THORNTON O'CONNOR
TOWN PLANNING

Response to Fingal County Council's Opinion

**In Respect of an Application for
Permission for a Large-Scale Residential
Development at a Site fronting Swords
to Malahide Road (R106), Mountgorry,
Swords, Co. Dublin**

**Submitted on Behalf of Bartra Propco
No. 23 Limited**

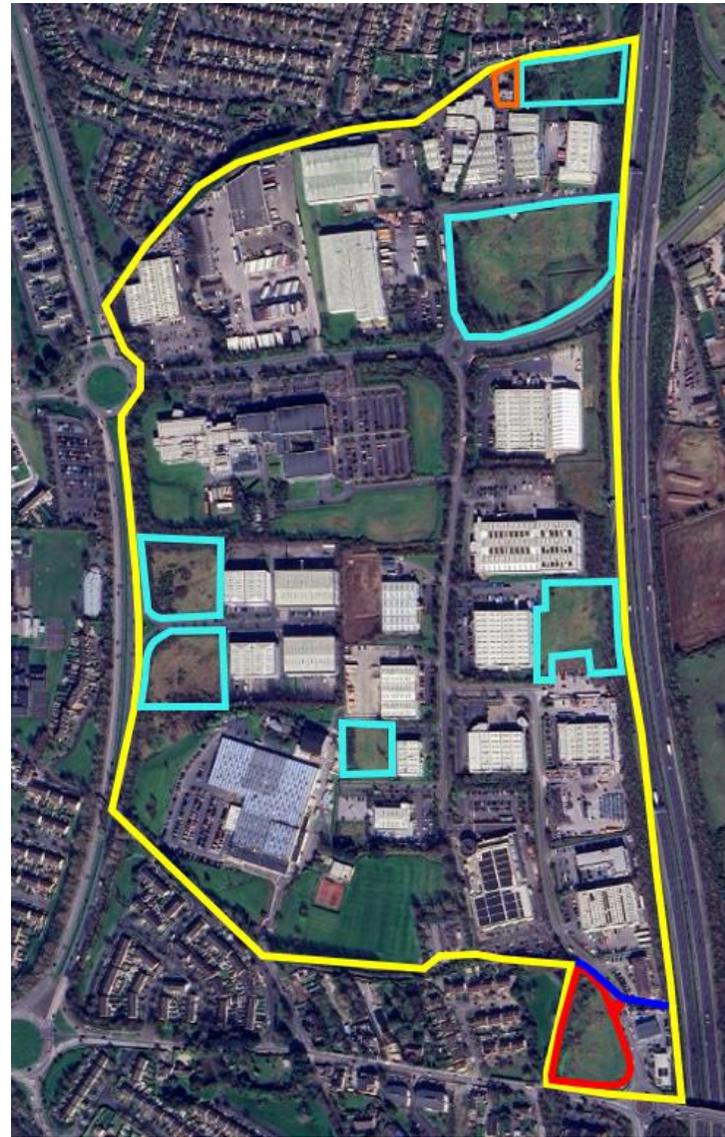
The below image illustrates all of the undeveloped land (outlined in light blue) within the MRE Zoning (outlined in yellow). Lands north of the dark blue line are within Swords Business Park. Also identified in the image is 'Annsbrook House' (outlined in orange) located to the north of Swords Business Park, which is the only residential property on the MRE zoned lands. The remaining developed land in Swords Business Park comprises wholly of commercial / industrial / manufacturing / office units, with no residential aspect evident.
